DOCUMENT 00 90 01 – ADDENDUM NO. 1

PROJECT: Inter-Garrison Road Water Distribution Pipeline
CIP NO.: OW-2421

FROM: District Engineer
Marina Coast Water District
920 2nd Avenue, Suite A
Marina, CA 93933

INTER-GARRISON ROAD WATER LINE
PLAN AND PROFILE STA.
16+50 - 25+50

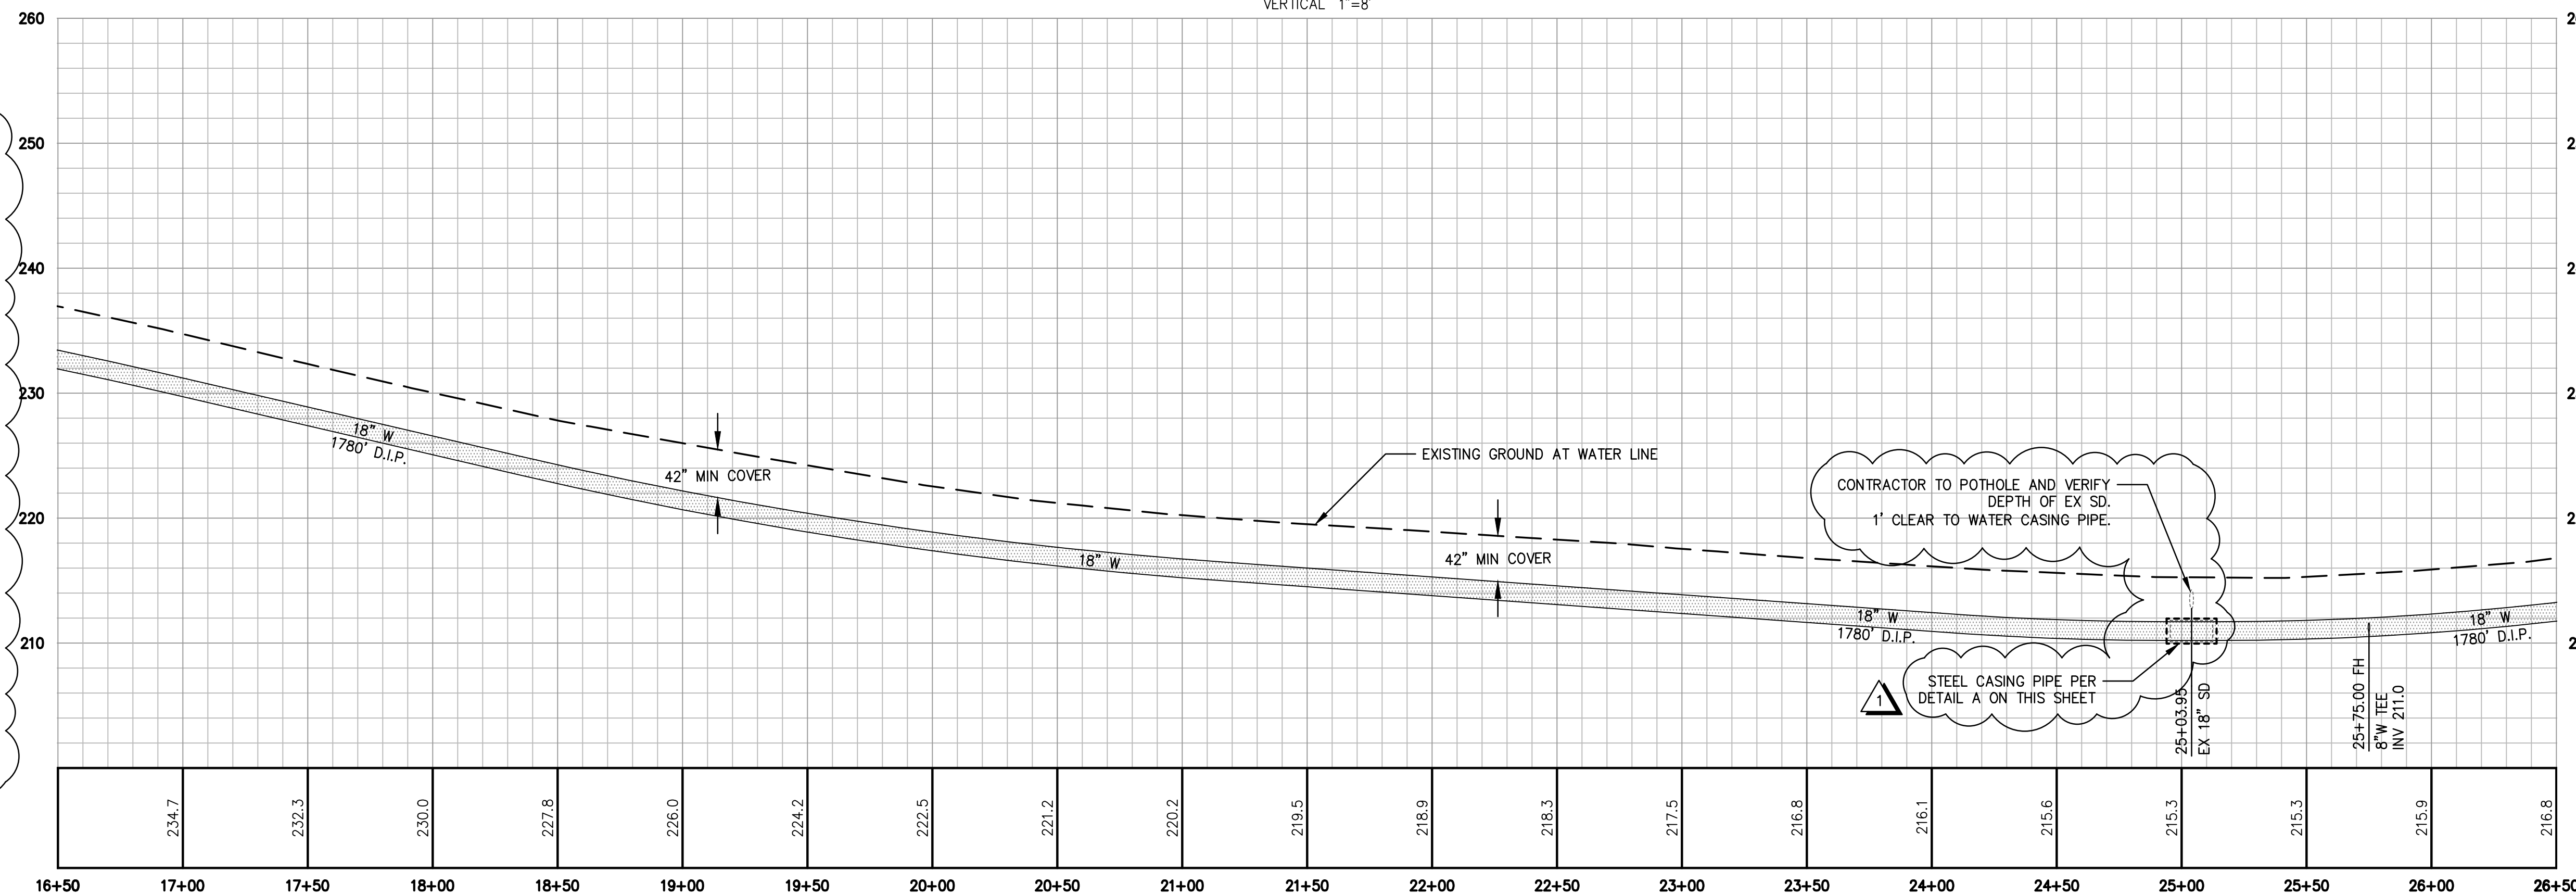
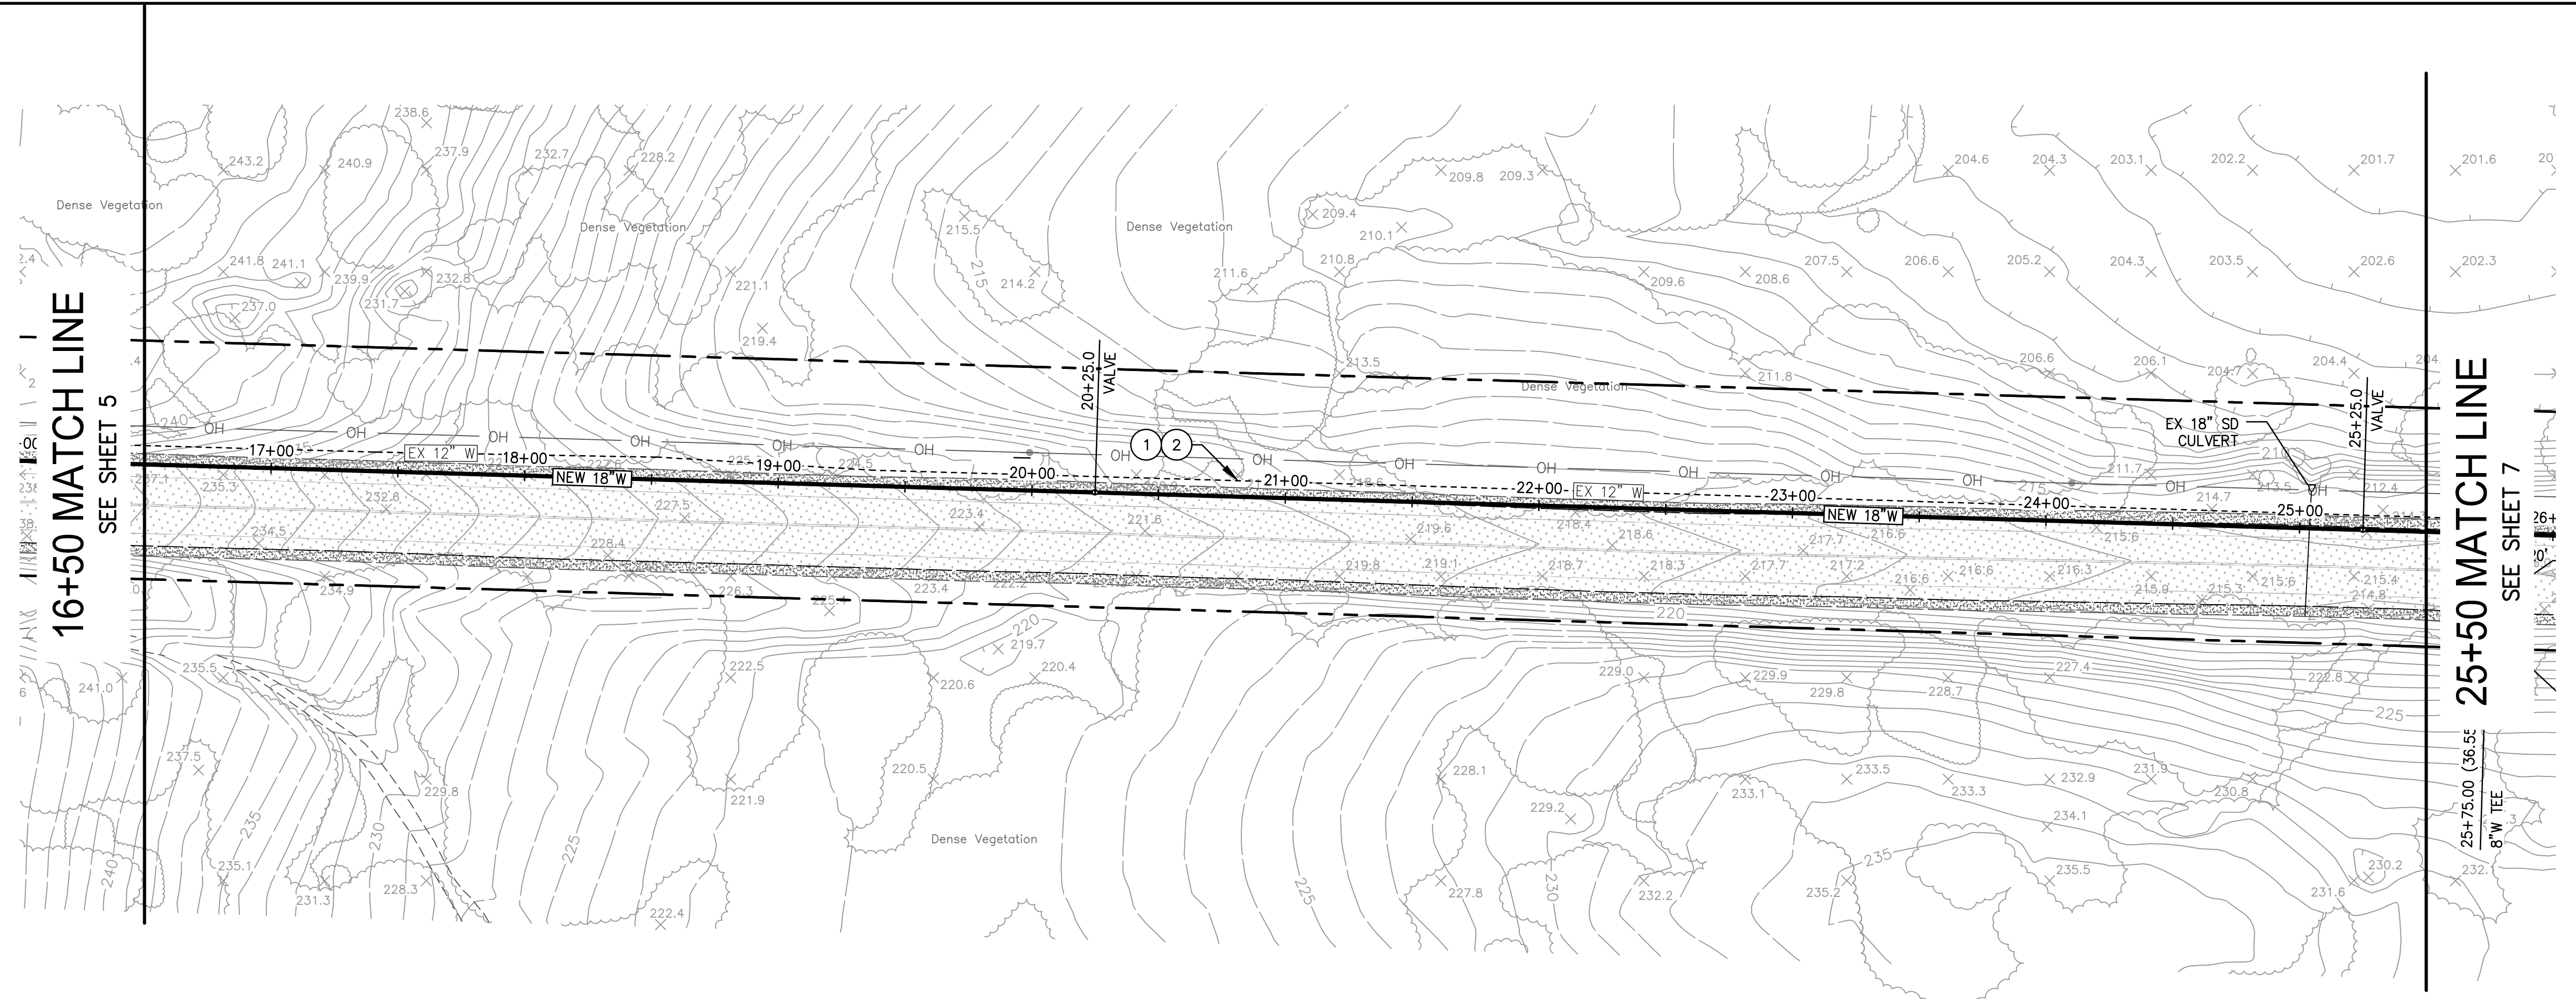
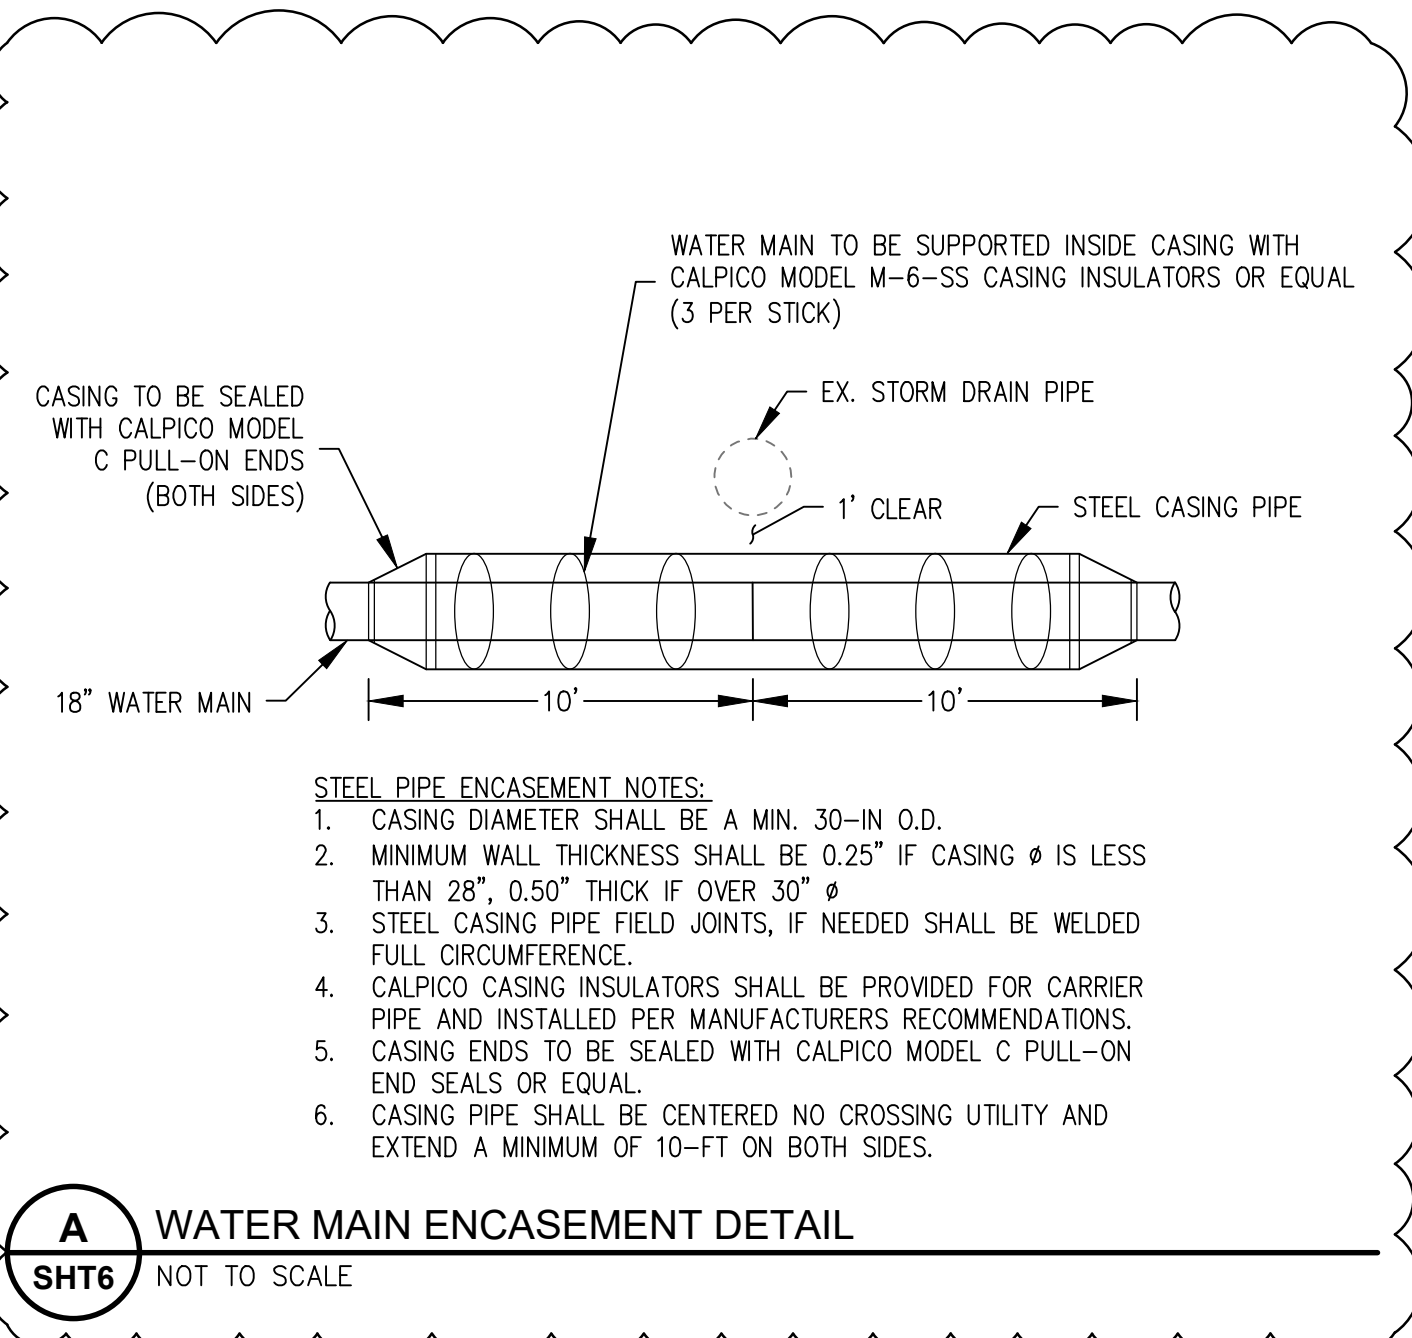
- A. A steel casing pipe was added at one (1) location per sheet No. 6. The PDF provided reflects this change, attached as Exhibit C.

NO.	REVISION DESCRIPTION	DATE	APPR
1	STEEL CASING UNDER EX. SD CROSSING	3/24/25
